UNITED STATES PATENT AND TRADEMARK OFFICE

APPLICATION NO.	FILING DATE	FIRST NAMED INVENTOR	ATTORNEY DOCKET NO.	CONFIRMATION NO.
10/791,052	03/01/2004	Kuo Tsung-Jung	251209-1150	2867
24504	7590	12/12/2006	EXAMINER	
THOMAS, KAYDEN, HORSTEMEYER & RISLEY, LLP 100 GALLERIA PARKWAY, NW STE 1750 ATLANTA, GA 30339-5948			KAYRISH, MATTHEW	
			ART UNIT	PAPER NUMBER
			2627

Office Action Summary	Application No. 10/791,052	Applicant(s) TSUNG-JUNG, KUO	
	Examiner Matthew G. Kayrish	Art Unit 2627

DETAILED ACTION

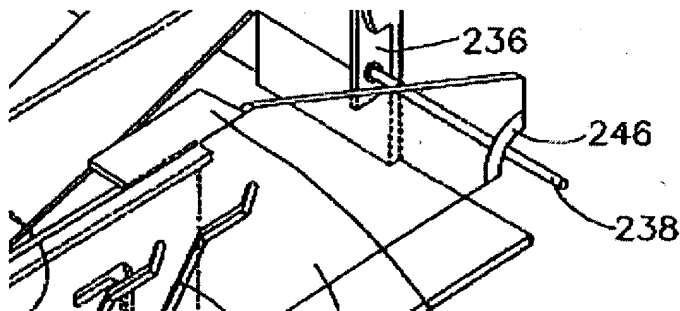
Regarding claim 20, Choi discloses:

A disk-anchoring device of an optical disk device, comprising:

A substrate (figure 3, item 216);

A clamper frame (figure 3, item 222) for holding a clamper (figure 3, item 222), pivoted (figure 3, pivots about item 234) on said substrate (figures 3 & 4) and having a first protrusion portion (figure 2, item 238);

A sliding element (figure 3, item 234), movably mounted on said substrate (column 3, lines 48-52) and having an inclined portion (figure 3, item 246) and a second protrusion (figure 2 below);

Wherein, when said sliding element is moved on said substrate, said first protrusion portion is relatively moved along said inclined portion so as to swing said clamber frame (column 5, lines 11-22).

Wherein after a disk is loaded into the optical disk device, said second protrusion portion abuts and pushes said first protrusion portion (figure 4, item 238 abuts item 246).

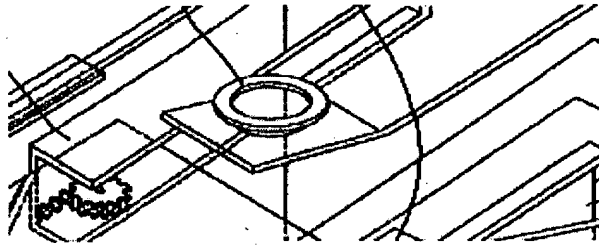
Regarding claim 23, Choi discloses:

The disk-anchoring device as claimed in claim 20, wherein said clamber frame has a clamping flange (figure 1 below), and said clamber is mounted on said clamping flange (figure 1, item 220 is supported by the clamber flange).
